SUBJECT: CYCLE 10 RELOAD ANALYSIS AND LICENSE AMENDMENT (TAC 67605)

Re: Quad Cities Nuclear Power Station, Unit 2

Amendment No. 104
License No. DPR-30

SAFETY EVALUATION BY THE OFFICE OF NUCLEAR REACTOR REGULATION
SUPPORTING AMENDMENT NO. 104 TO FACILITY OPERATING LICENSE NO. DPR-30

FIGURE 2.1-3
(SCHEMATIC)

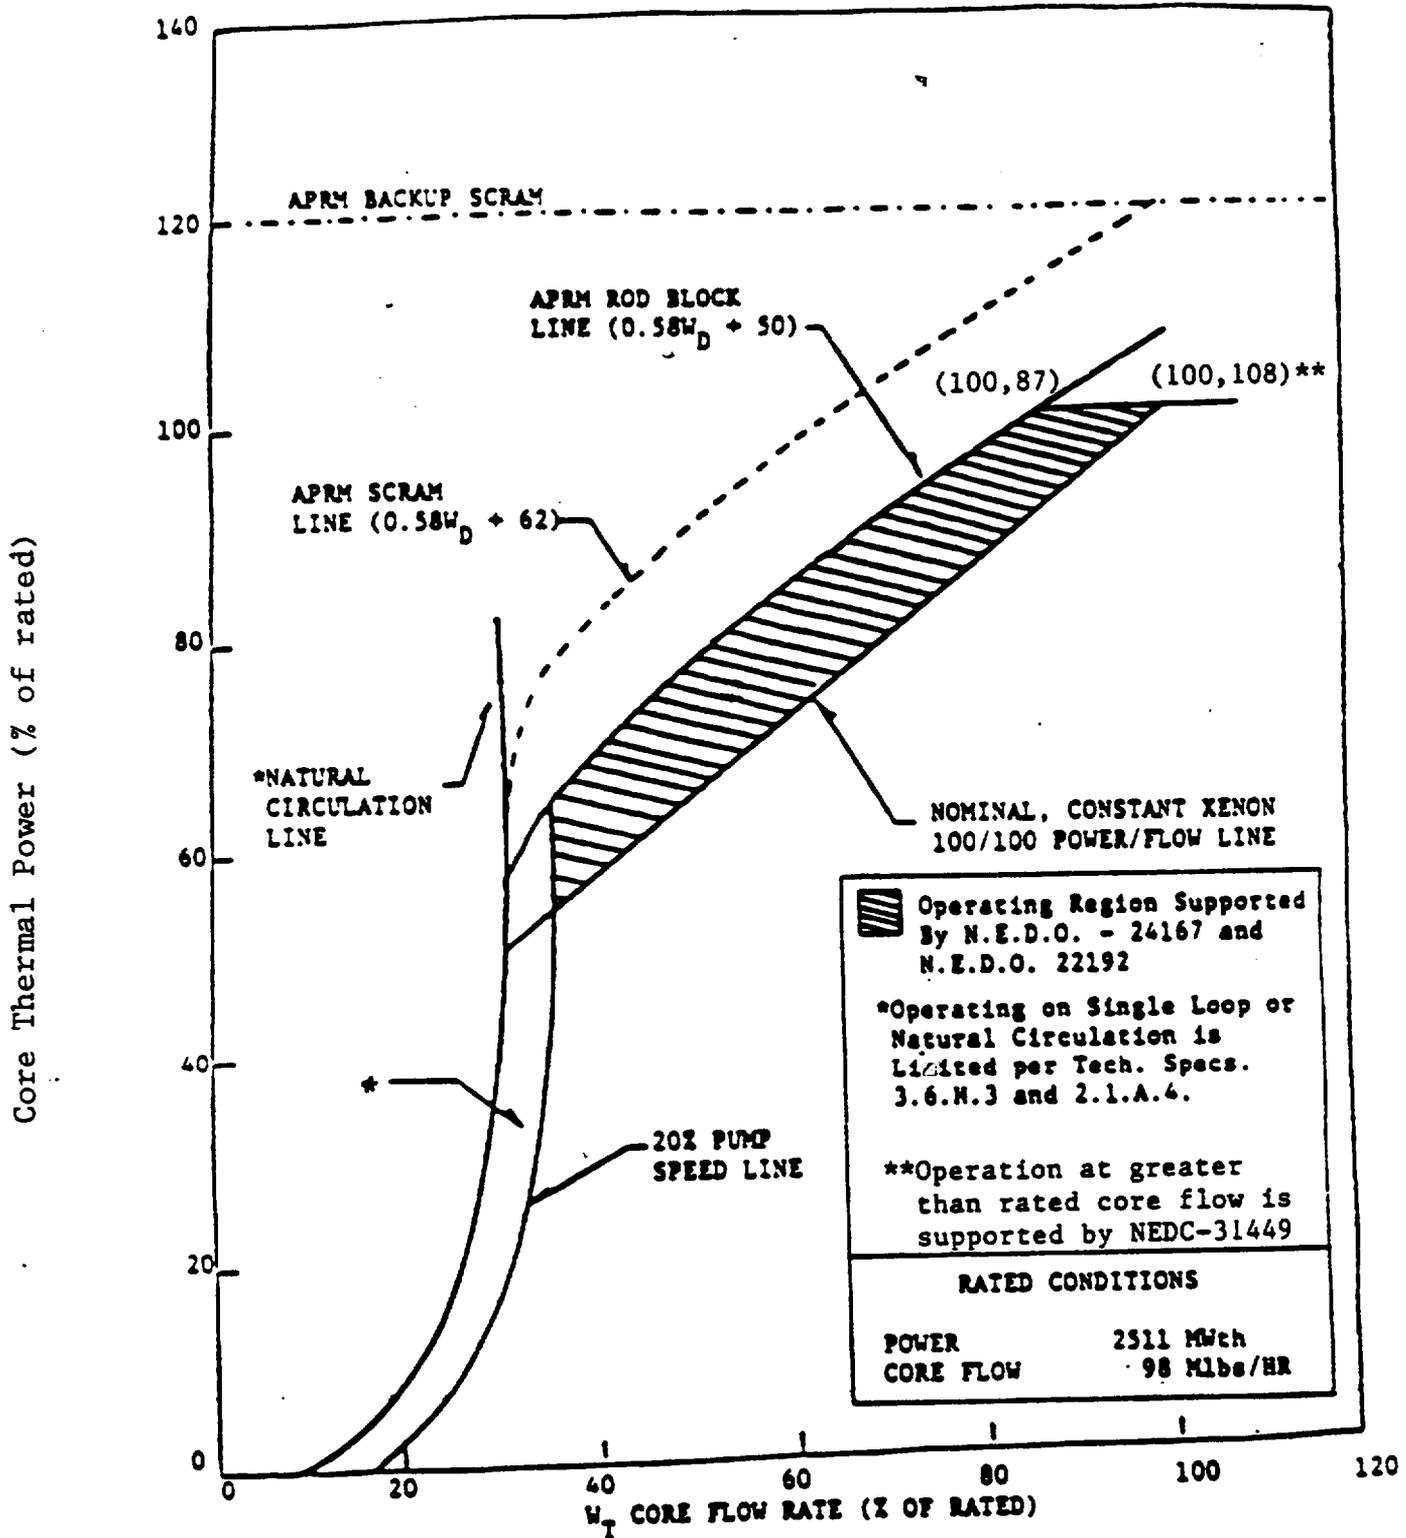
5. Figure 2.1-3

Add operating region as defined by the increased core flow analysis which is evaluated in Section 2.6 of this SER. This is acceptable.

10. Figure 3.5-1

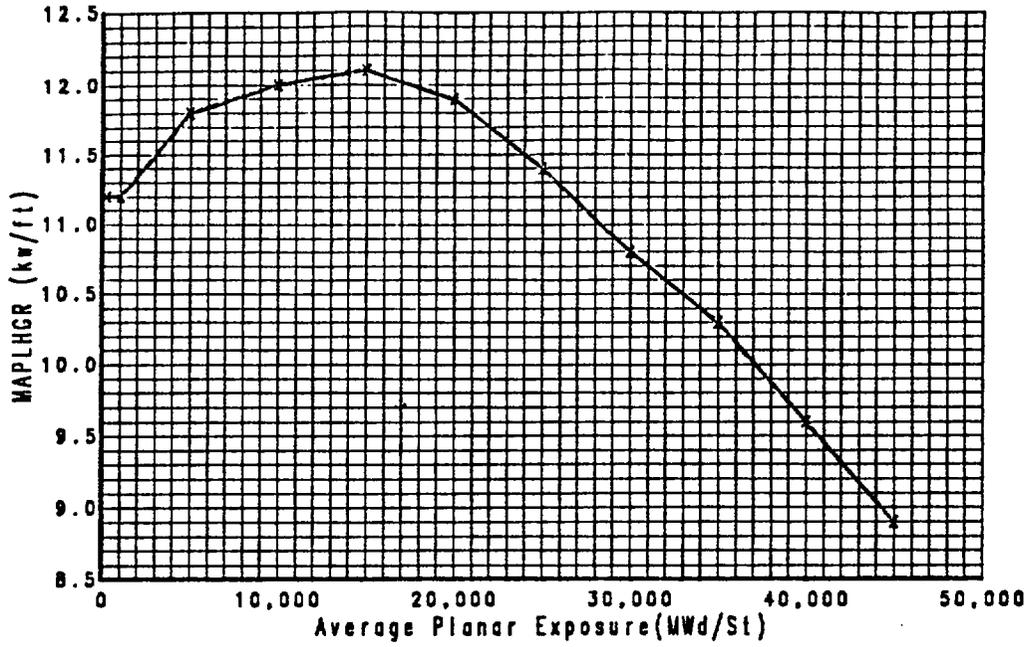
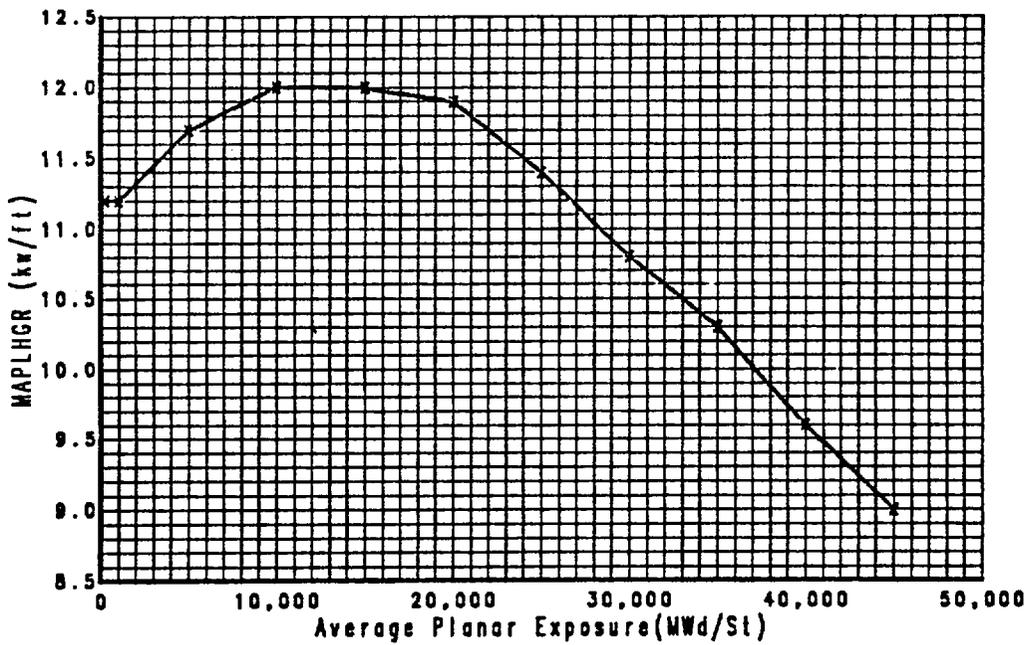
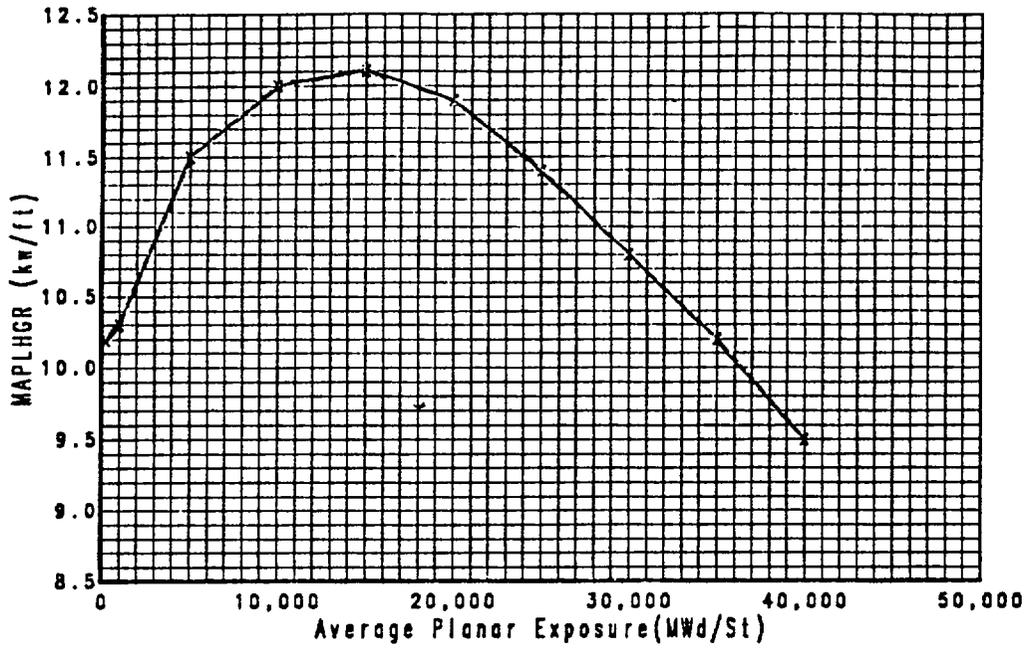
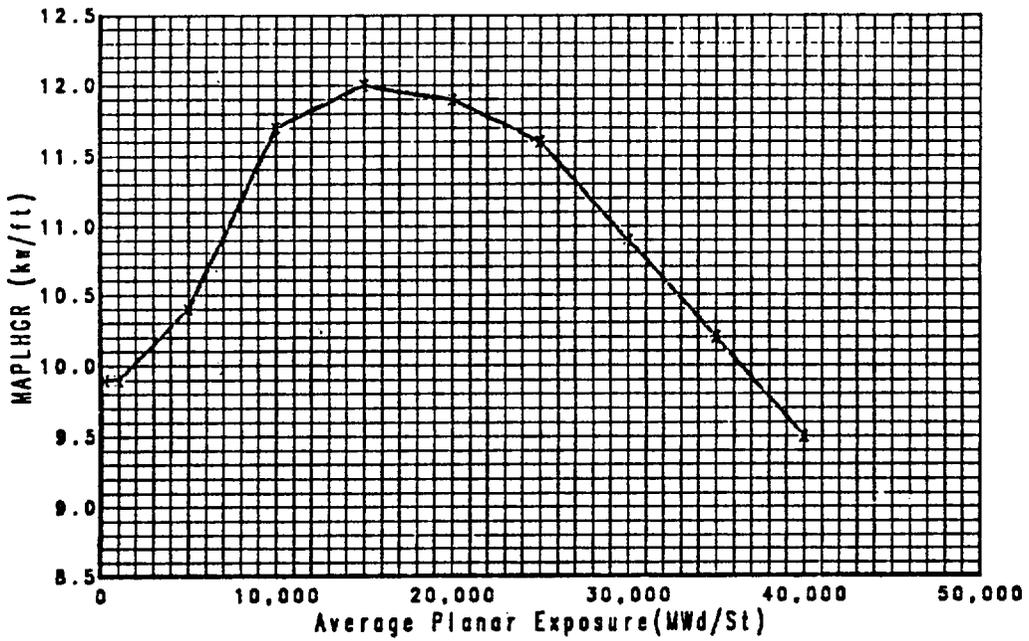
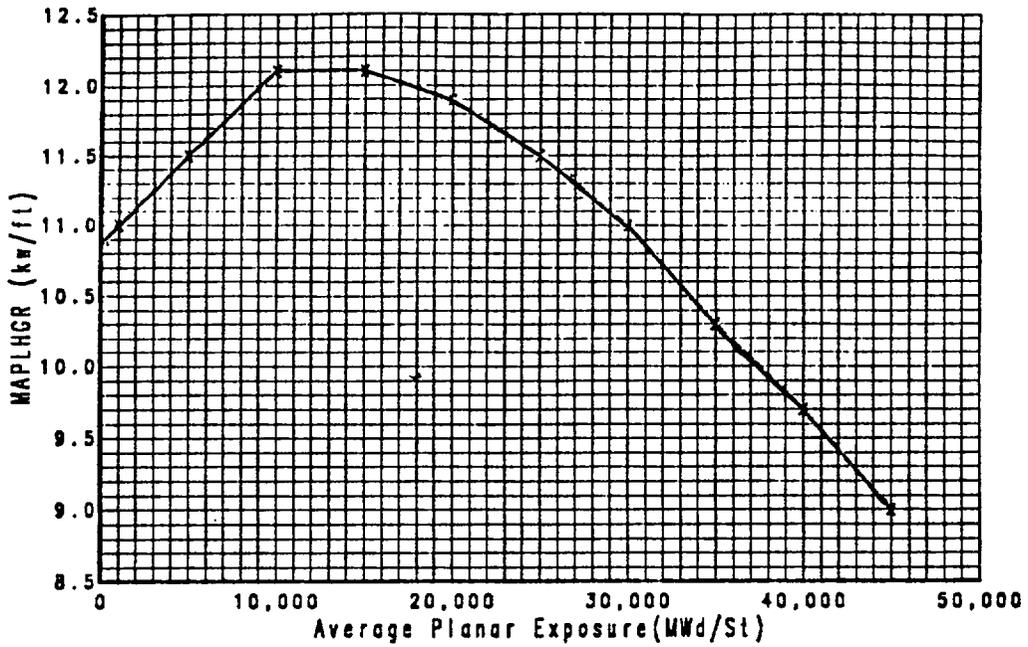
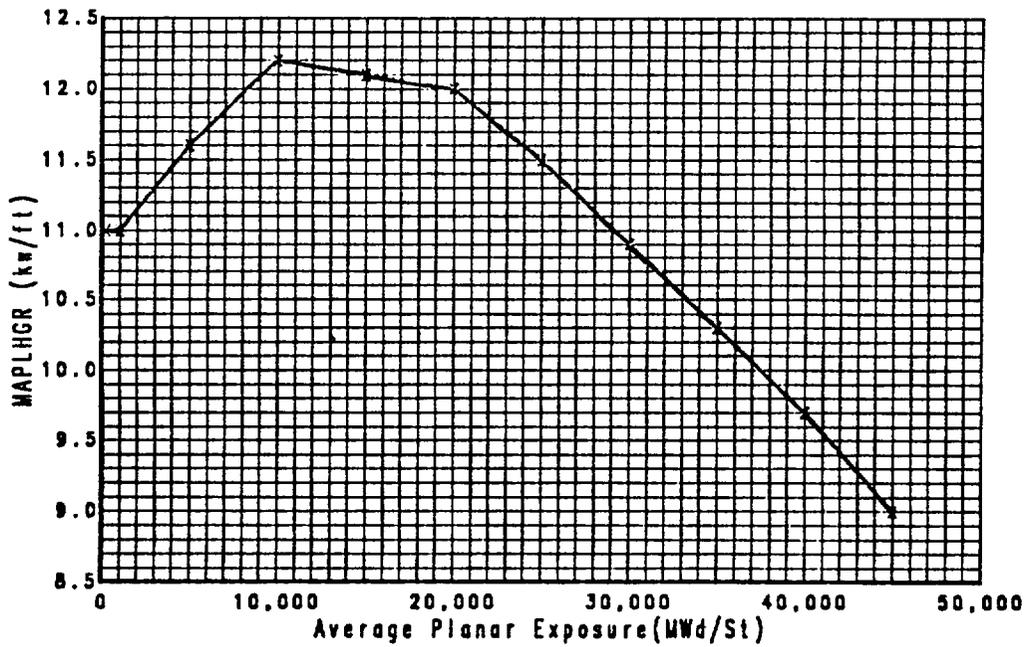
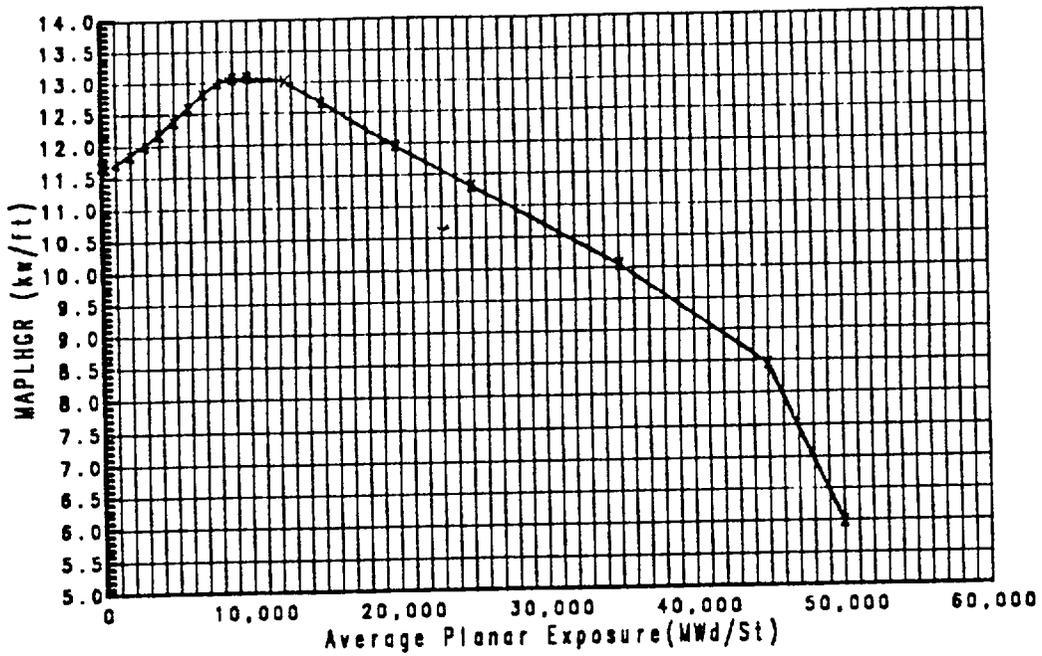
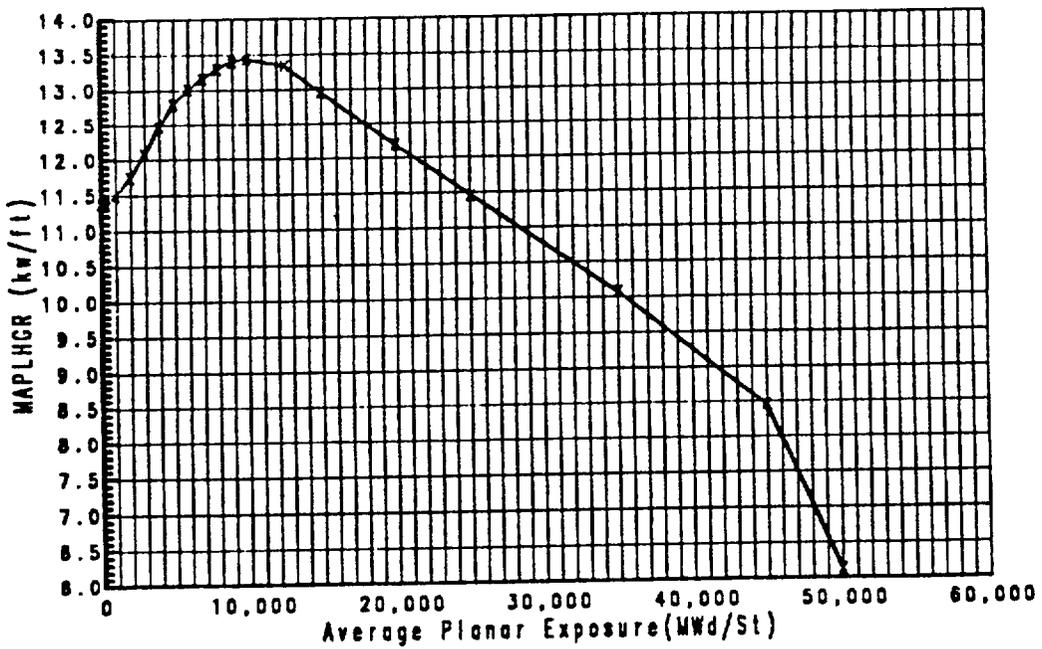
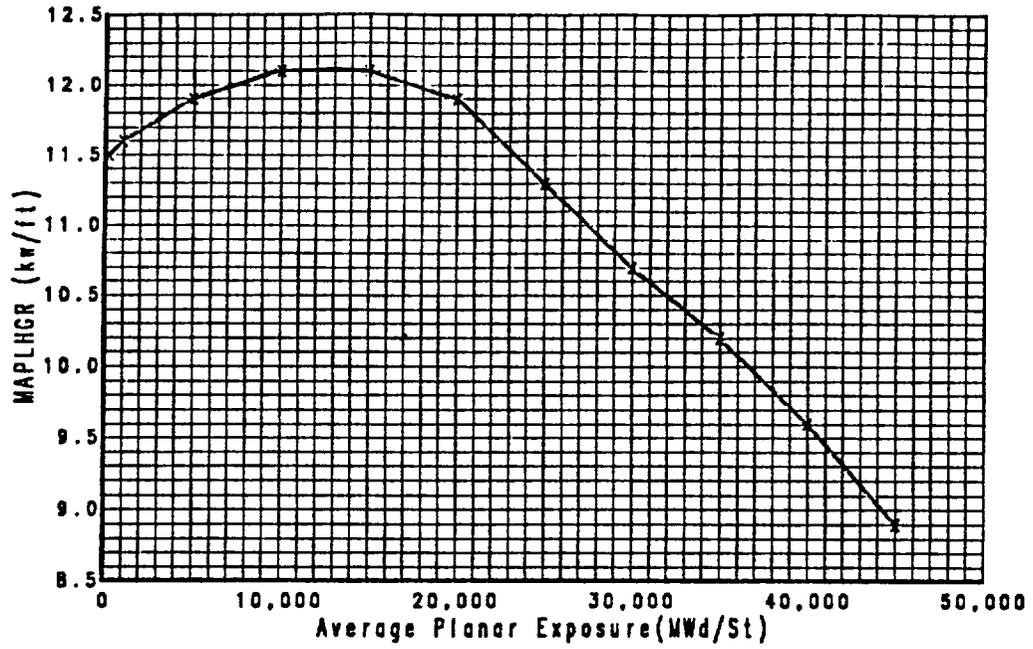
Add new MAPLHGR curves for new fuel types BD300C and BD316A and delete MAPLHGR curves for fuel types no longer in use. This is acceptable.

FIGURE 3.5-2

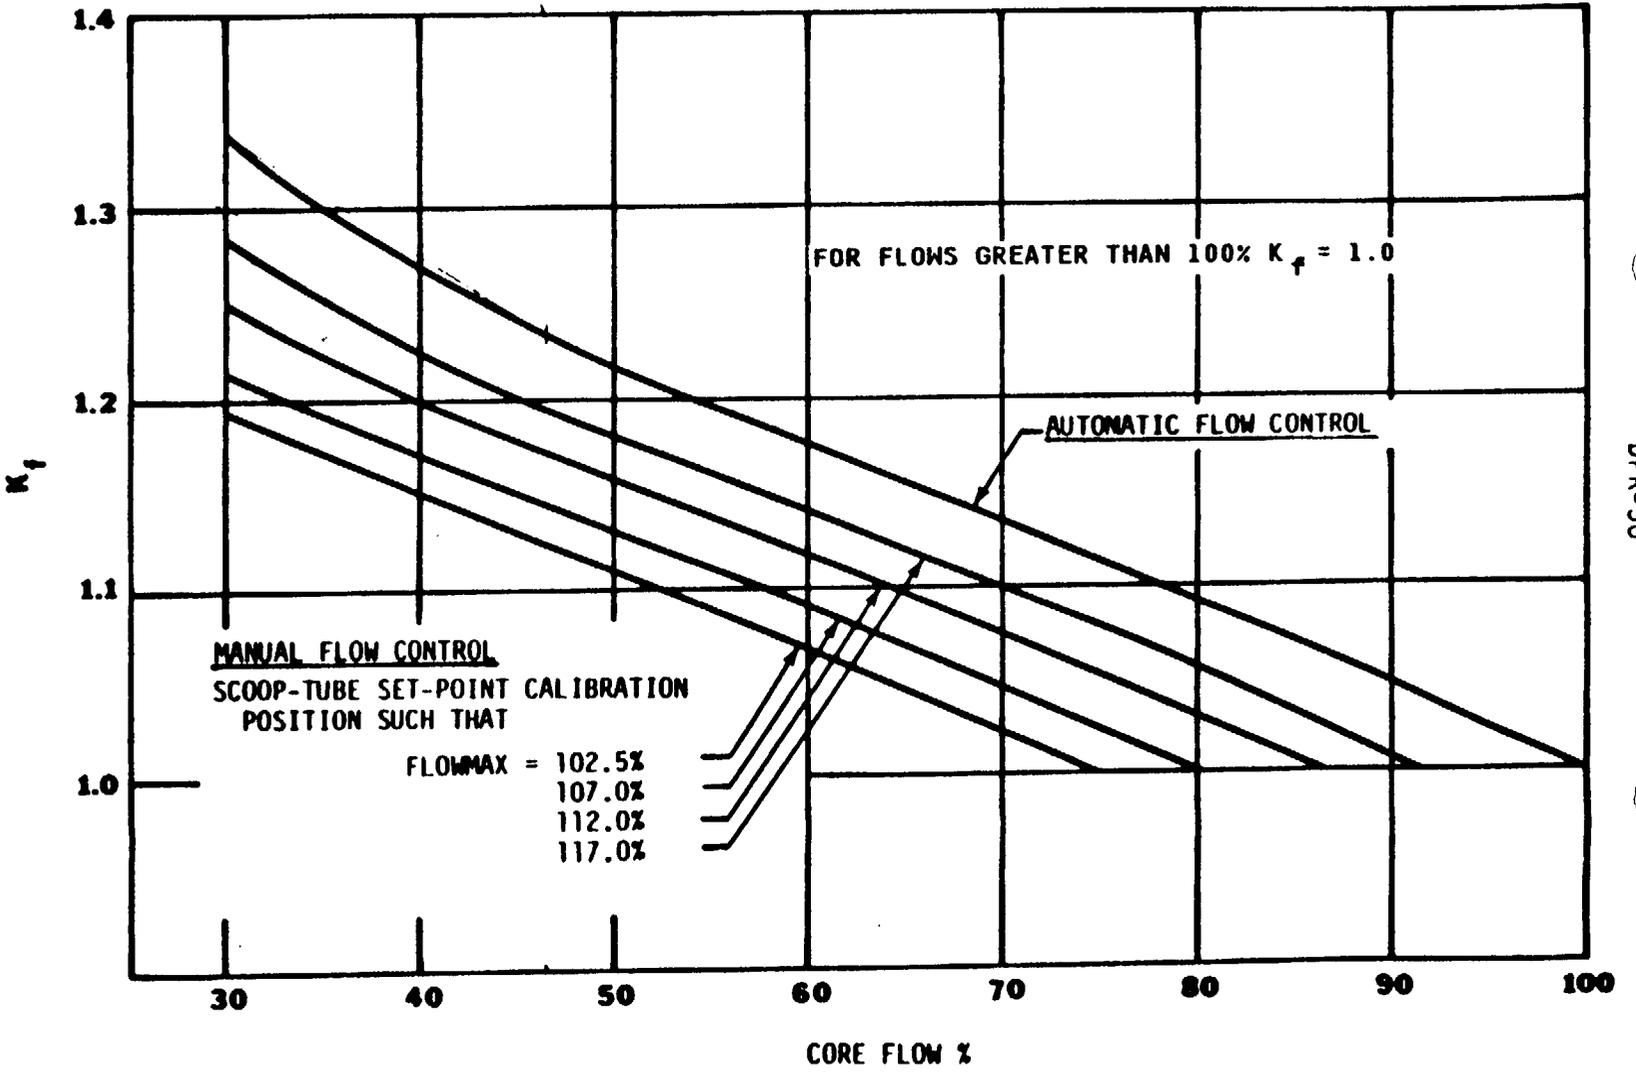
11. Figure 3.5-2
Add the statement "For flows greater than 100%, $K_f = 1.0$ " to the figure to address the operating region defined by the ICF analysis. This is acceptable.
12. TS 3.6.H.3 on page 3.6/4.6-5a and TS Bases on page 3.6/4.6-13a
Delete the MAPLHGR reduction factor during single loop operation based on the SAFER/GESTR-LOCA analysis. This is acceptable since an approved method was used. Revise RBM upscale limit due to new RBM setpoint. Reduce the allowed duration of unrestricted SLO to 12 hours.
